# Value Engineering

### Removal of Elwha and Glines Canyon Dams, Elwha River Ecosystem and Fisheries Restoration Project

April 25, 2003

Bureau of Reclamation, Technical Service Center, Denver, Colorado

Figure 11. Gates

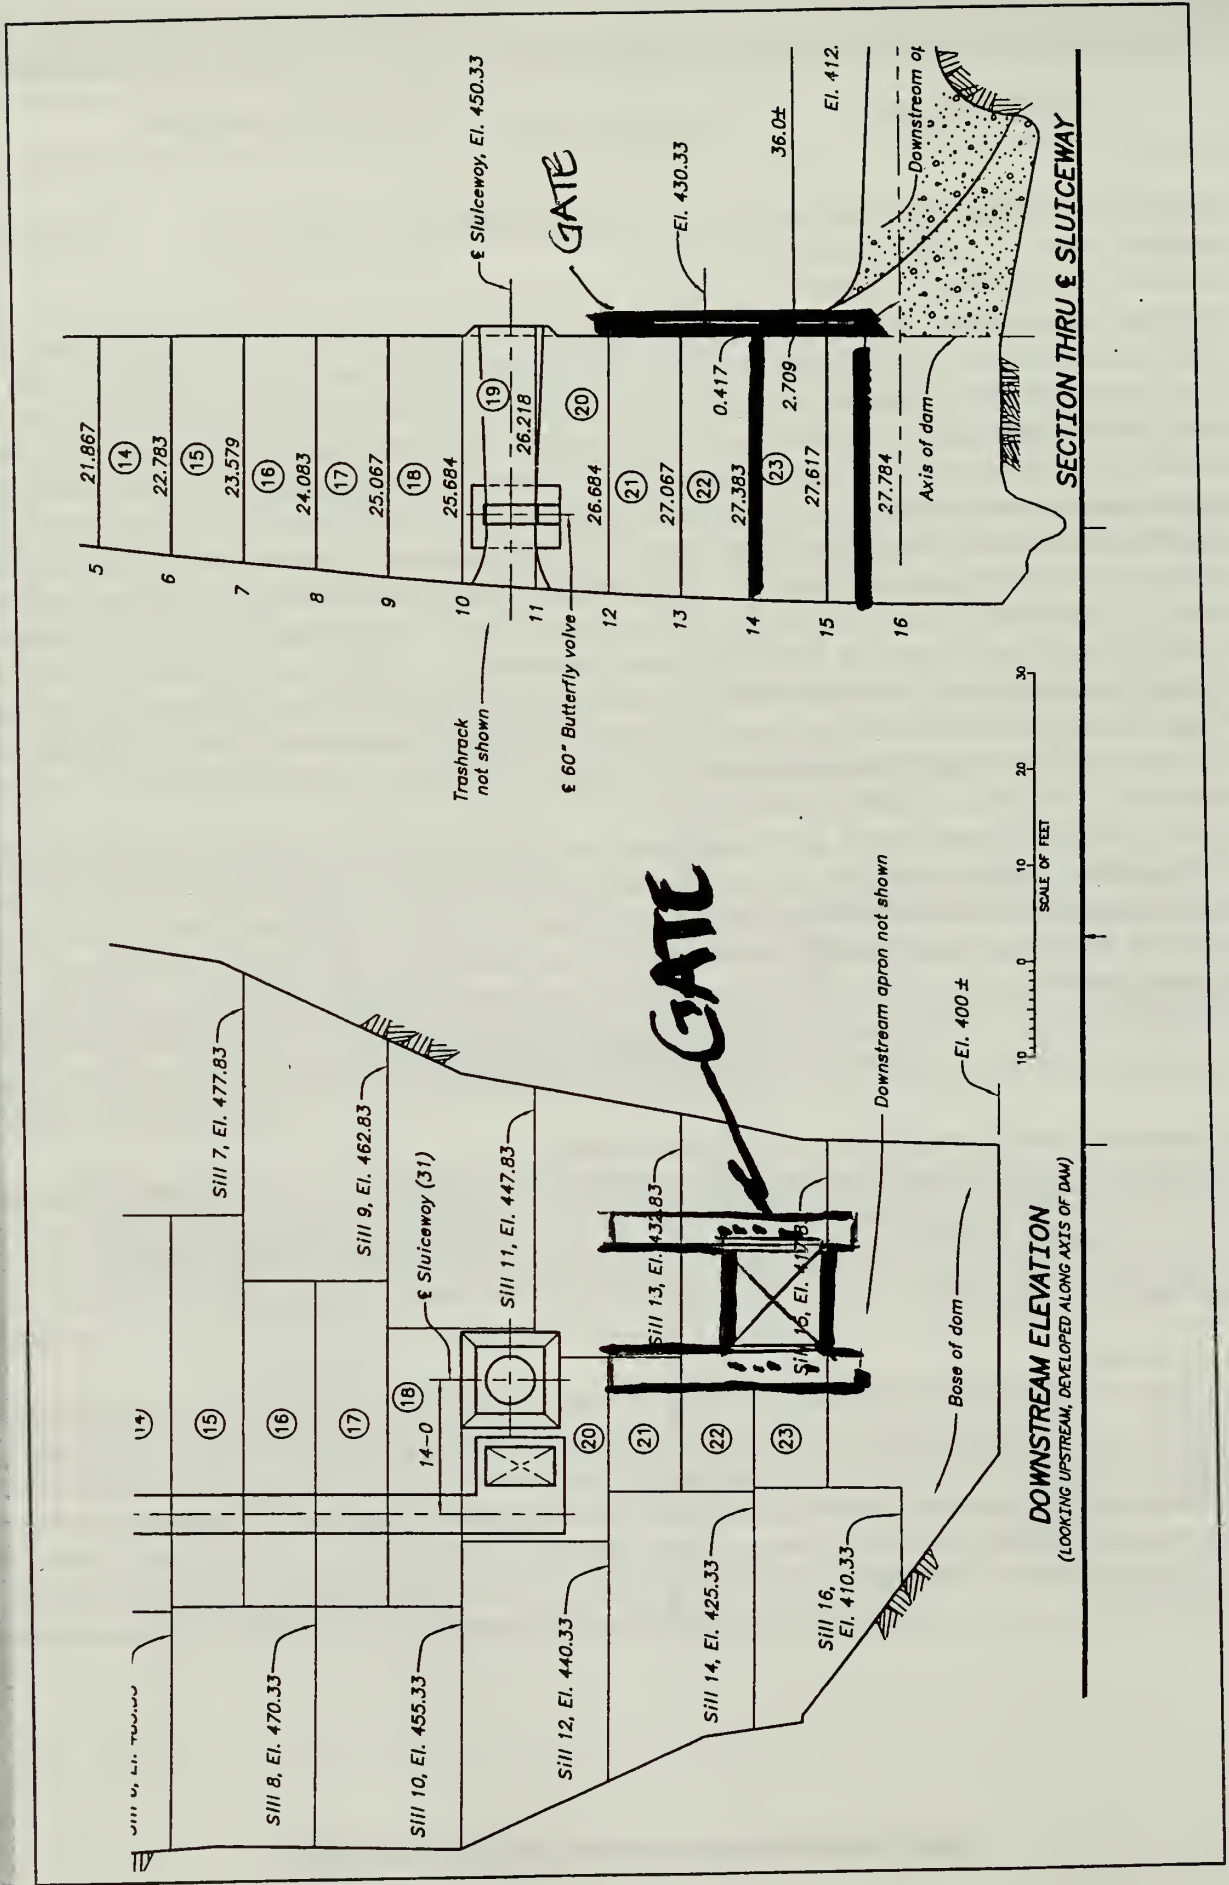
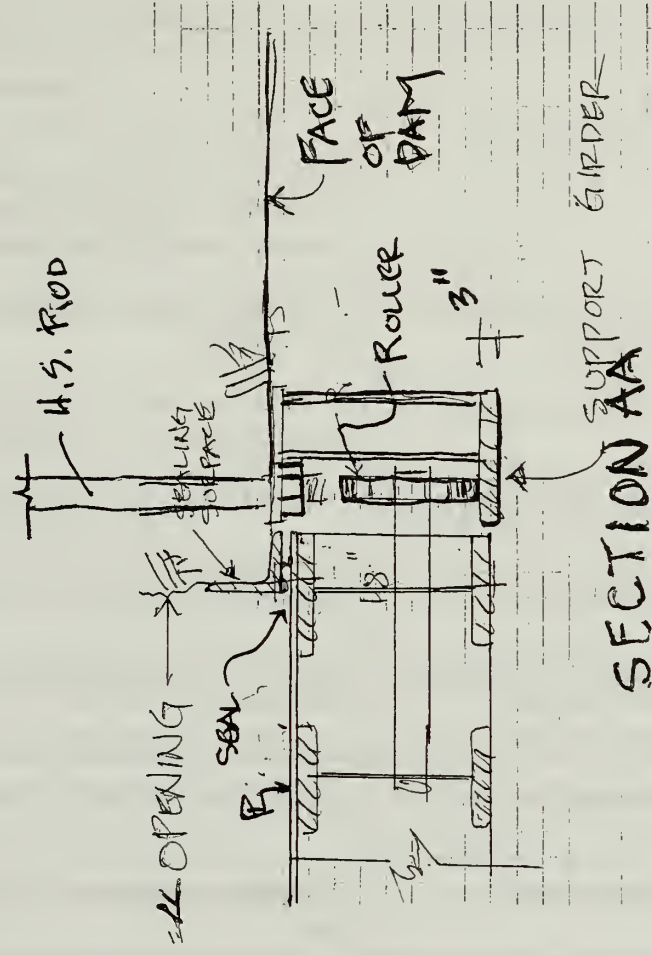
- Proposal Description: Construct low level outlet work with gate/valve control near the base of the dam at approximately elevation 425-430 ft. (see Figures 11 and 12 for one possible concept). Remove (dredge) sediment for approximately 200 ft. upstream of the dam prior to daylighting through the upstream side. Draw down Lake Mills and redistribute and release sediments using existing spillway, penstock, and low level outlet to elevation ~425 ft. following decommissioning of Glines Canyon powerplant approximately one year prior to dam removal. Each drawdown increment to elevation 470 ft. will be 10 ft. followed by 10 days to 2 weeks at constant elevation to facilitate sediment redistribution. Following sediment redistribution to elevation 470 ft. refill Lake Mills. Upon removal of Elwha Dam to elevation 110 ft. resume and complete drainage of Lake Mills. Drawdown below elevation 470 ft. will be at rates that accomodate downstream fish management, and sediment delivery and transport objectives. Dam demolition will commence following drawdown of the reservoir and will proceed at maximum rates unconstrained by fish or sediment management considerations.
